MAHONING ROAD NE
 STA-0153-01.70

REVISIONS:
 CONSTRUCTION BIDDING SET
 APPENDIX NO. 1

REVISIONS	DATE	BY
CONSTRUCTION BIDDING SET	4/21/14	GEA
ADDENDUM NO. 1	5/7/14	GEA

PR.SIGNAGE & PAVEMENT MARKING PLAN STA. 66+50 TO STA. 78+00	CALCULATED: GEA CHECKED: JGC	SCALE: HORIZONTAL SCALE: 1" = 20' VERTICAL SCALE: 1" = 40'	
	REVISIONS CONSTRUCTION BIDDING SET APPENDIX NO. 1	DATE BY 4/21/14 GEA 5/7/14 GEA	75 108

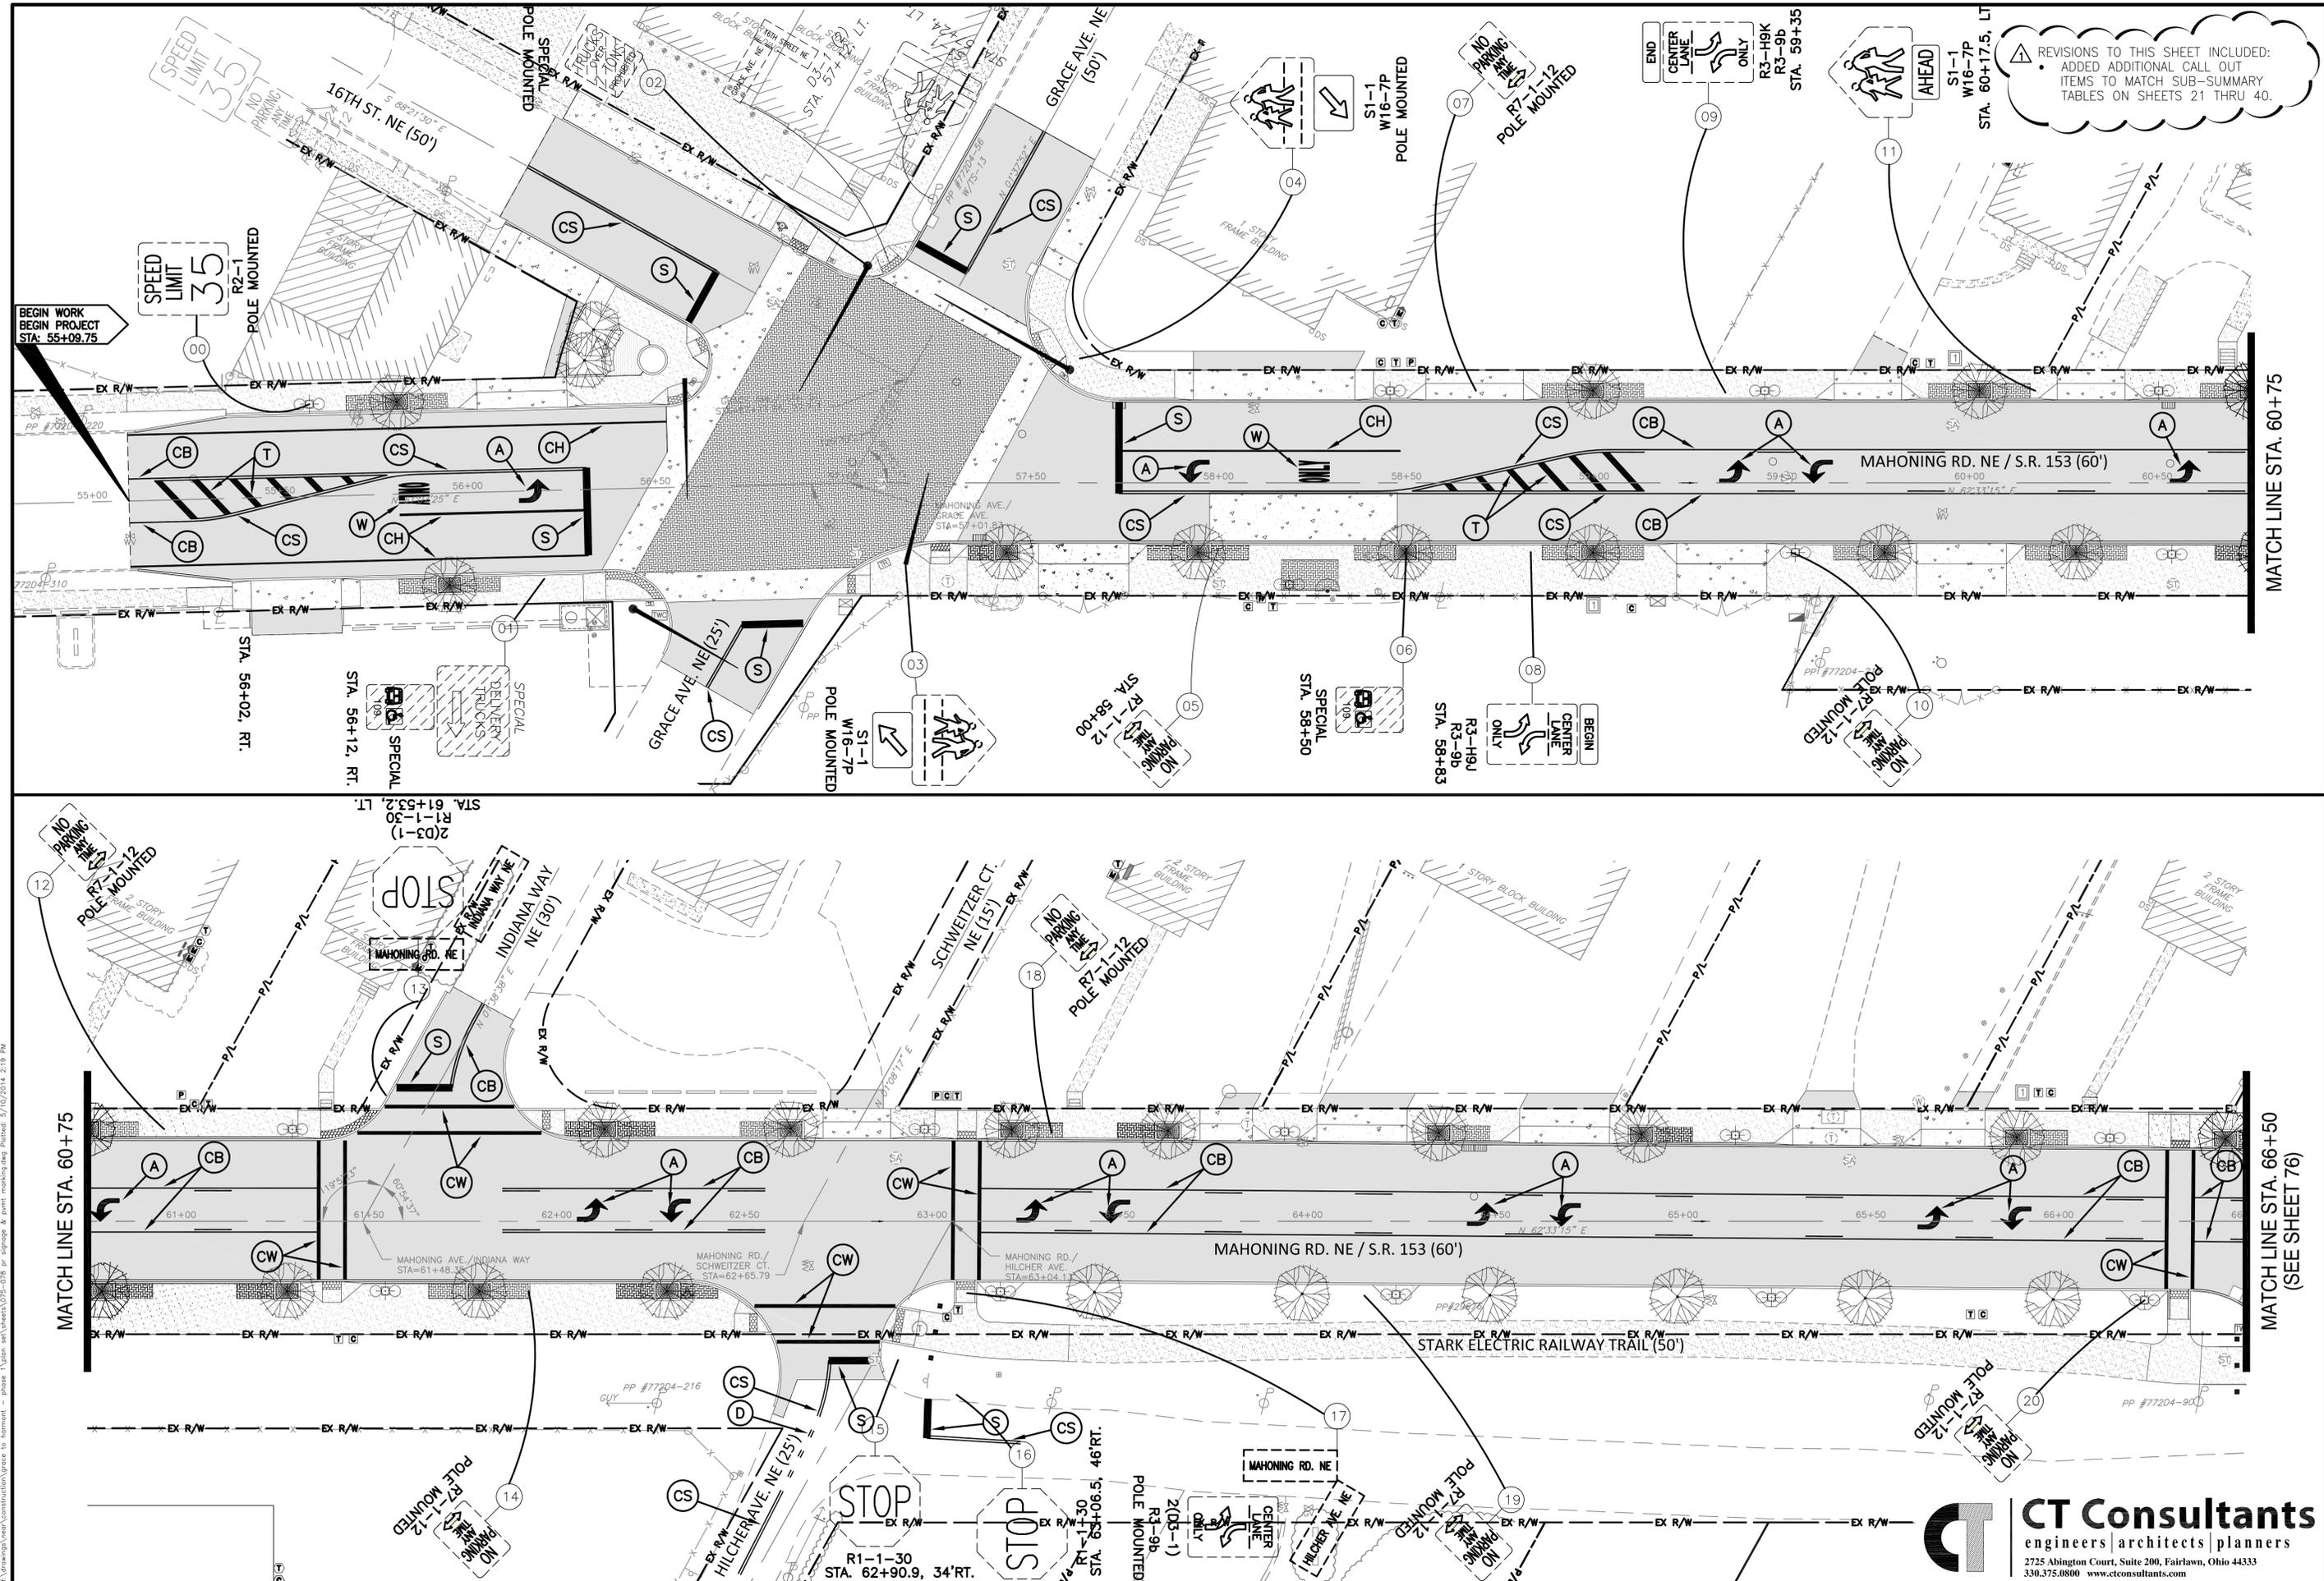
REVISIONS TO THIS SHEET INCLUDED:
• ADDED ADDITIONAL CALL OUT ITEMS TO MATCH SUB-SUMMARY TABLES ON SHEETS 21 THRU 40.

CALCULATED: GEA CHECKED: JCG
PR. SIGNAGE & PAVEMENT MARKING PLAN STA. 78+00 TO STA. 89+50	
DATE: 4/21/14 BY: GEA	REVISIONS: CONSTRUCTION BIDDING SET: APPENDUM NO. 1 5/7/14 GEA
MAHONING ROAD NE STA-0153-01.70	
SPECIAL MOUNTED POLE MOUNTED

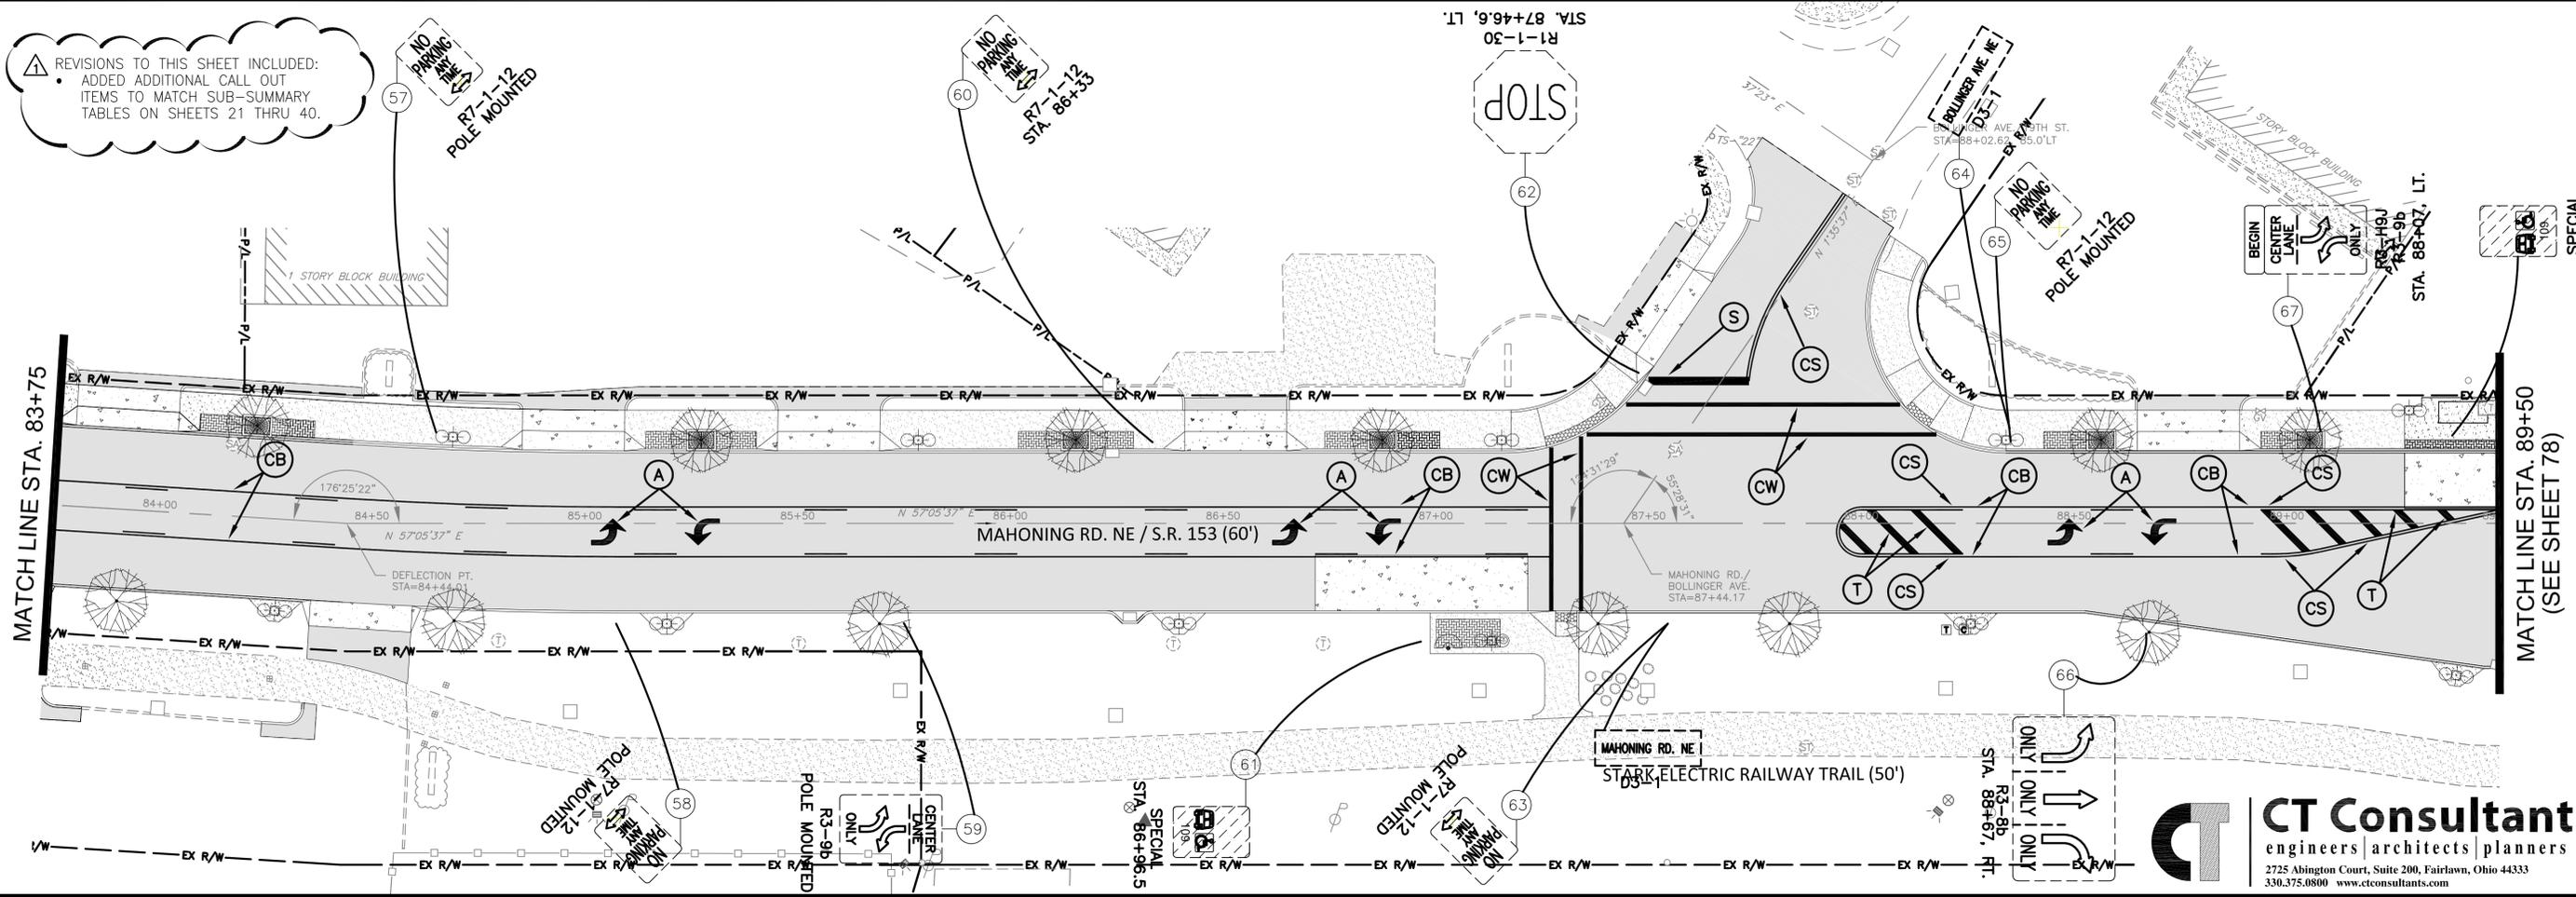
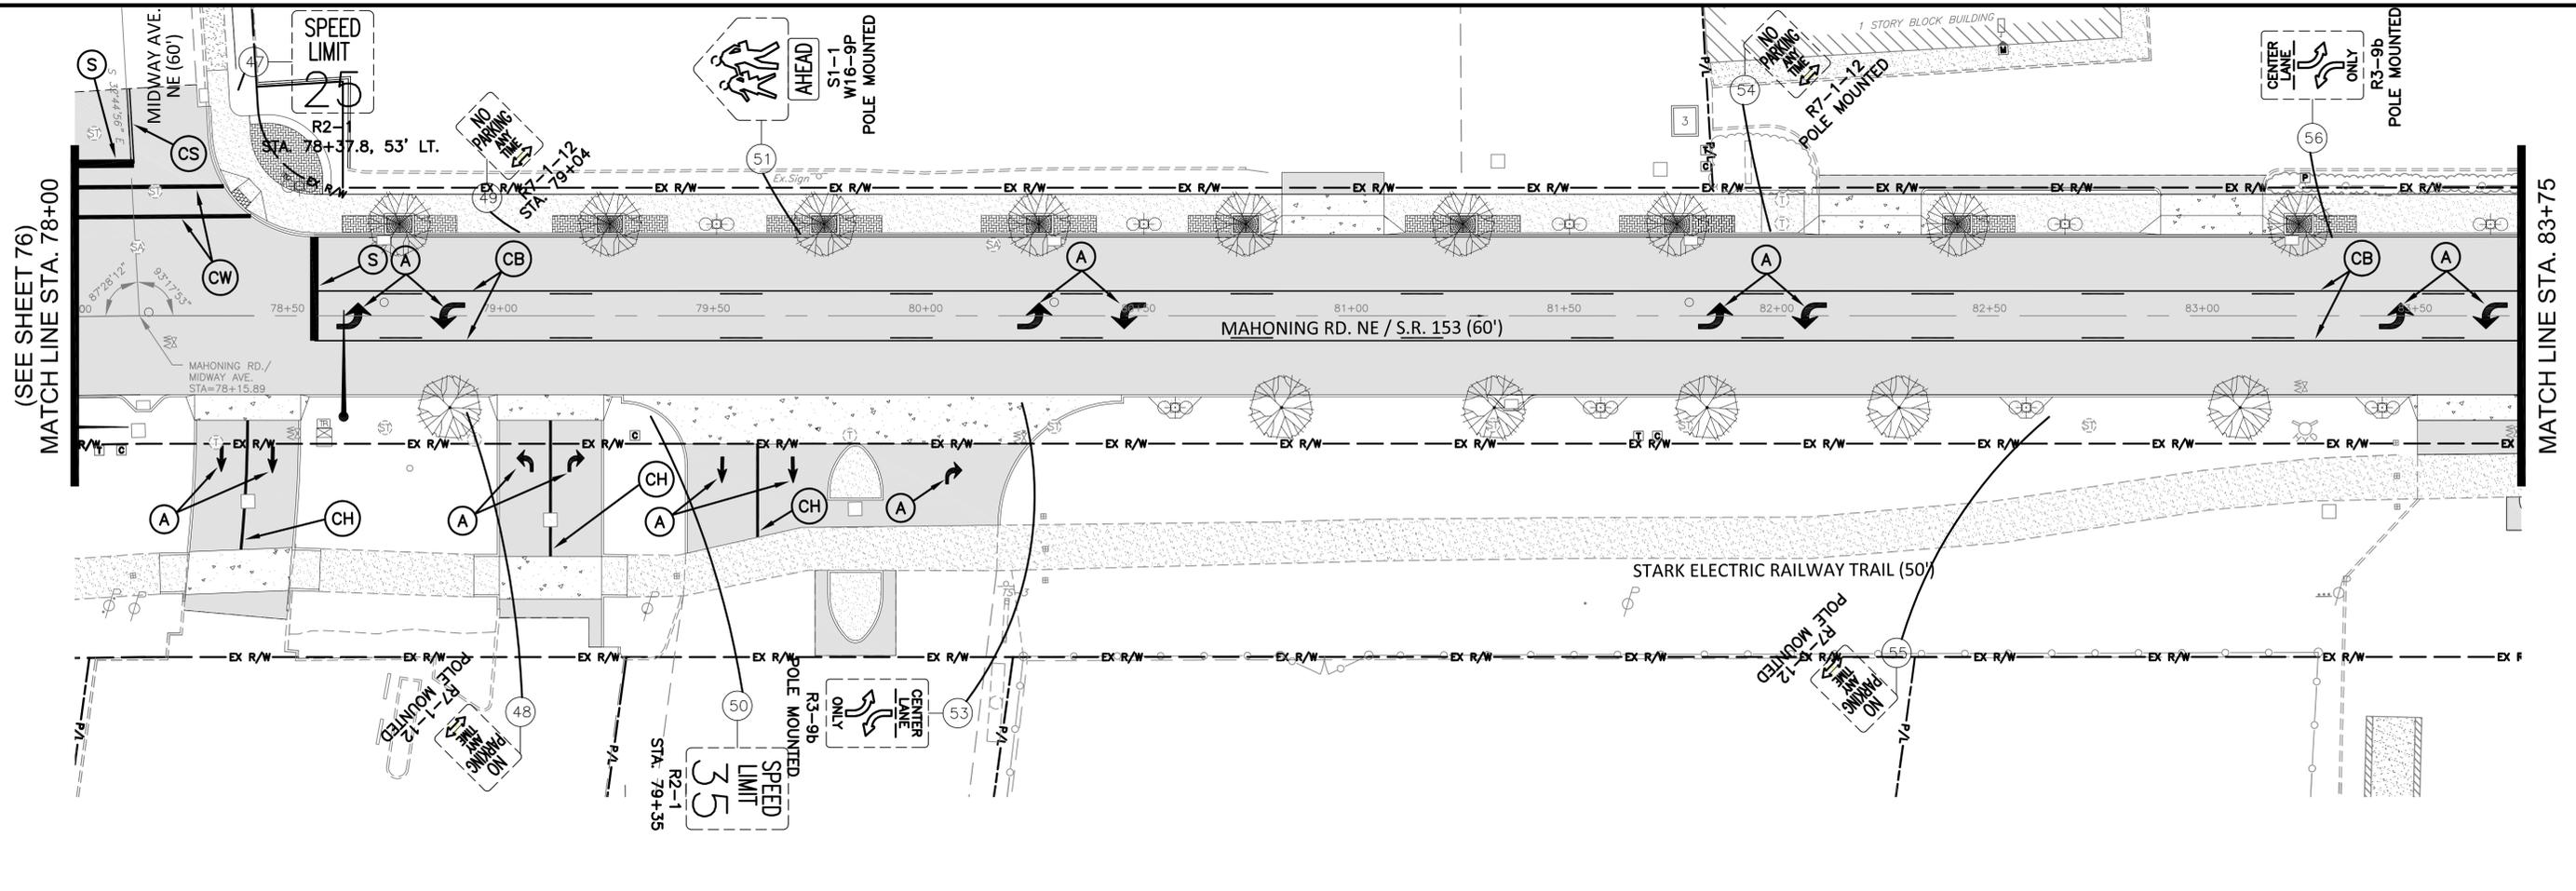
REVISIONS TO THIS SHEET INCLUDED:
 • ADDED ADDITIONAL CALL OUT ITEMS TO MATCH SUB-SUMMARY TABLES ON SHEETS 21 THRU 40.
